# CITY OF ALBUQUERQUE

**Re: 4700 Eubank Development**  
**4700 Eubank Blvd. NE**  
**Traffic Circulation Layout**  
Architect's Stamp 10-25-22 (F21-D073)

Based upon the information provided in your submittal received 11-14-22, the above referenced plan cannot be approved for Building Permit until the following comments are addressed:

AS101a

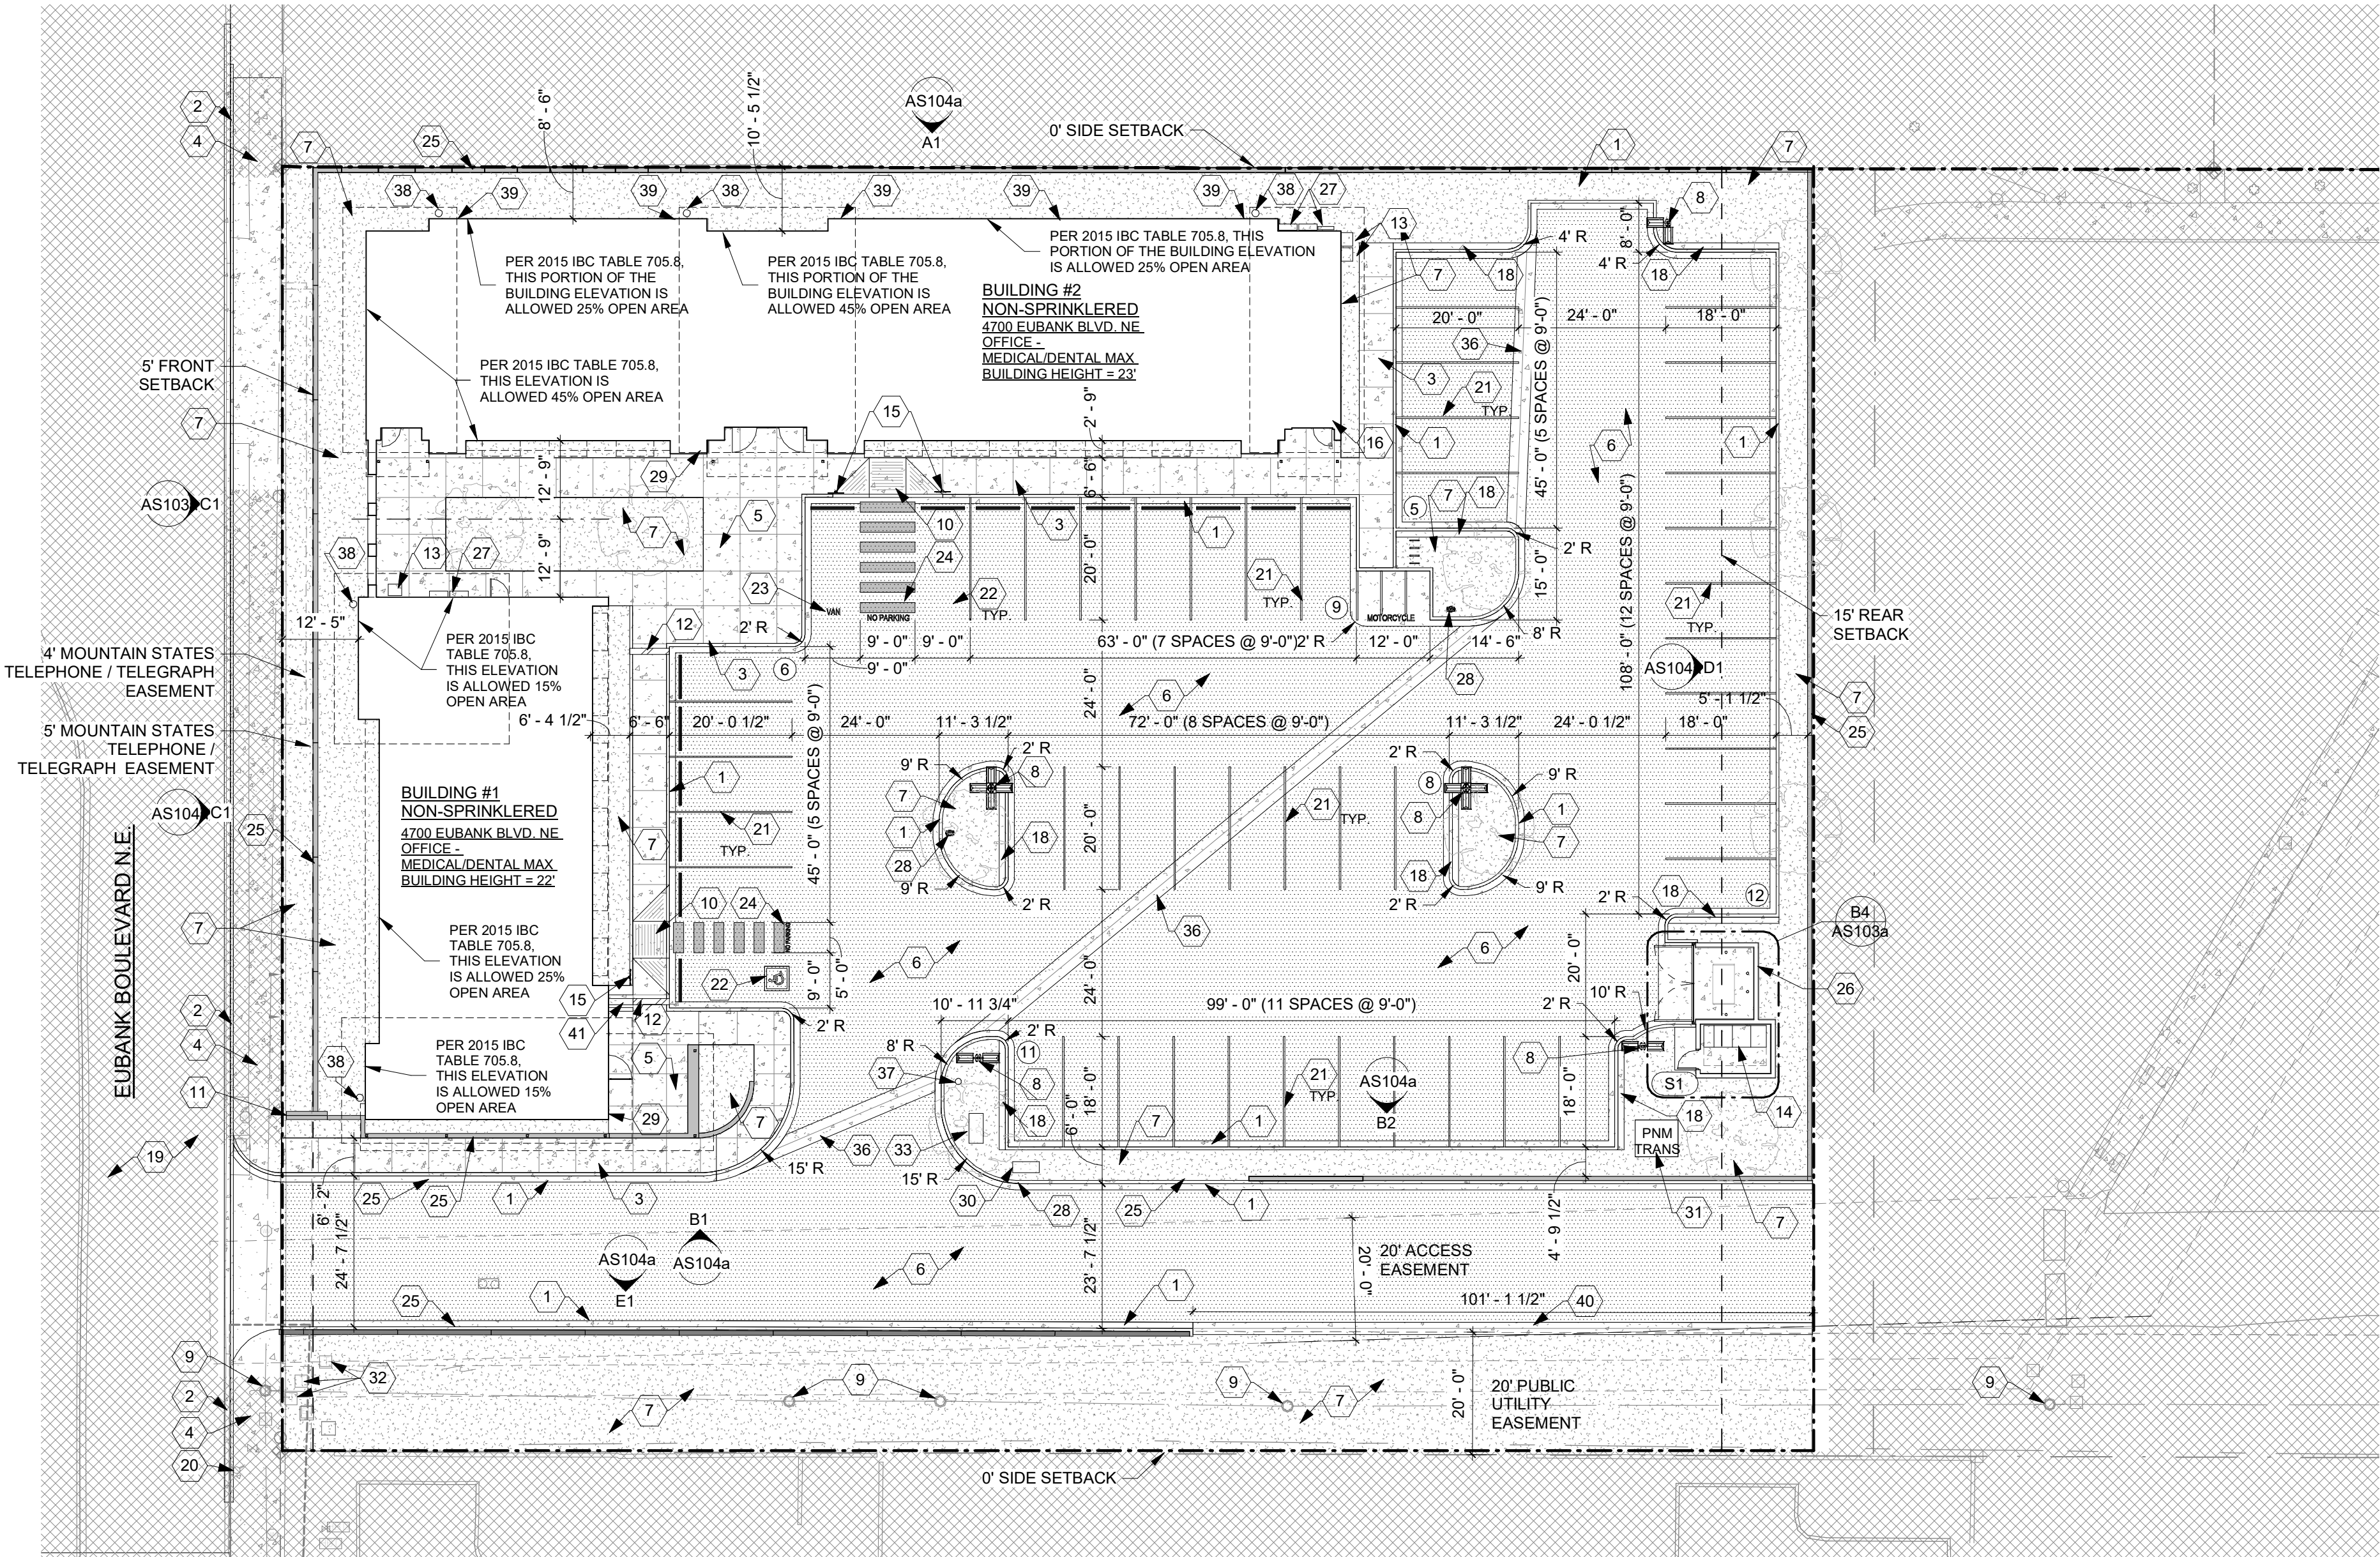
1. Please show a vicinity map showing the location of the development in relation to streets and well known landmarks.
2. Identify all existing access easements and rights of way width dimensions.

3. Identify the right of way width, medians, curb cuts, and street widths on Eubank Blvd. NE.
4. Driveway access off Eubank Blvd.: this access need to be built per COA std dwg 2426, and radius need to be provided. Radius for delivery trucks, fire trucks, etc. is 25 ft. or larger.

5. Key note 10: Provide details for the interior ADA ramps, or reference COA std dwg.
6. Key note 16: Please revise the site plan because key note 16 is referring to the building and it should be referred to the Bike Rack. Also, please provide Bike Racks' details.

7. ADA curb ramps on the City Right of Way must be updated to current standards and have truncated domes installed.
8. Motorcycle parking spaces shall be designated by its own conspicuously posted upright sign, either free-standing or wall mounted per the zoning code.

9. The pavement marking "MC" should be shown in the opposite direction for motorcycles entering the parking space.
10. Refuse vehicle maneuvering shall be contained on-site. The refuse vehicle shall not back into the public right of way. provide a copy of refuse approval.

11. Provide a copy of Fire Marshal approval.
12. Show the clear sight triangle and add the following note to the plan: "Landscaping and signage will not interfere with clear sight requirements. Therefore, signs, walls, trees, and shrubbery between 3 and 8 feet tall (as measured from the gutter pan) will not be acceptable in the clear sight triangle.

13. Please specify the City Standard Drawing Number when applicable.

14. Unused curb cuts must be replaced with sidewalk and curb & gutter. A build note must be provided referring to the appropriate City Standard drawing.
15. Add a note stating "All broken or cracked sidewalk must be replaced with sidewalk and curb & gutter." A build note must be provided referring to the appropriate City Standard drawing.
16. Please provide a letter of response for all comments given.
17. Traffic Studies: See the Traffic Impact Study (TIS) thresholds. In general, a minimum combination of 100 vehicles entering and exiting in the peak hour warrants a Traffic Impact Study. Visit with Traffic Engineer for determination, and fill out a TIS Form that states whether one is warranted. In some cases, a trip generation may be requested for determination (**Contact Matt Grush: [mgrush@cabq.gov](mailto:mgrush@cabq.gov)**).
